# AGENDA ITEM SUMMARY REPORT

**APPLICATION NO.:** Sign Permit (SA 5-18)

**REQUEST:** Reconsider Sign Permit Special Condition 3 for Sinclair

**LOCATION:** 863 North Main Street

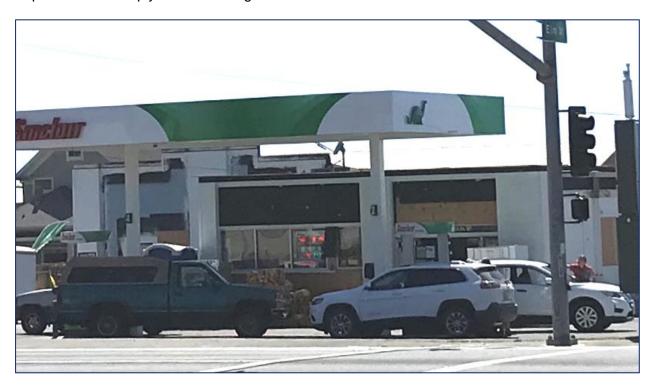
3. On the canopy sign neither the Sinclair nor the logo dinosaurs may be internally or externally illuminated.

The applicant did not attend the meeting and upon hearing of the Special Condition 3 expressed some distress about the prohibition against lighting the company name and the dinosaur logo.

The applicant noted that other gas station business names and logos on canopies are lighted throughout Fort Bragg. The applicant feels that the Special Condition is unfair.

Sinclair would like to illuminate the Sinclair name and dinosaur logo on the canopy. The Sign Permit 5-18 sign permit analysis considered the company name part of the signage allowance for the site. Thus lighting of the Sinclair word on the Canopy is normal and in compliance with the CLUDC and all past sign review and approval practice in the City of Fort Bragg. Sign Permit 5-18 did not include the dinosaur logo as part of the signage allowance. It was instead considered "art", which was a generous interpretation of our sign ordinance. The Planning Commission has more leeway to consider not allowing illumination of the dinosaur.

1. Staff recommends that the Planning Commission reconsider Special Condition 3 of Sign Permit 5-18. Staff recommends that the company's name "Sinclair" be allowed to be illuminated. Illumination of the Dinosaur logo would be consistent with the canopies of other gas stations in town; however the Planning Commission could choose not to allow the logo to be illuminated.
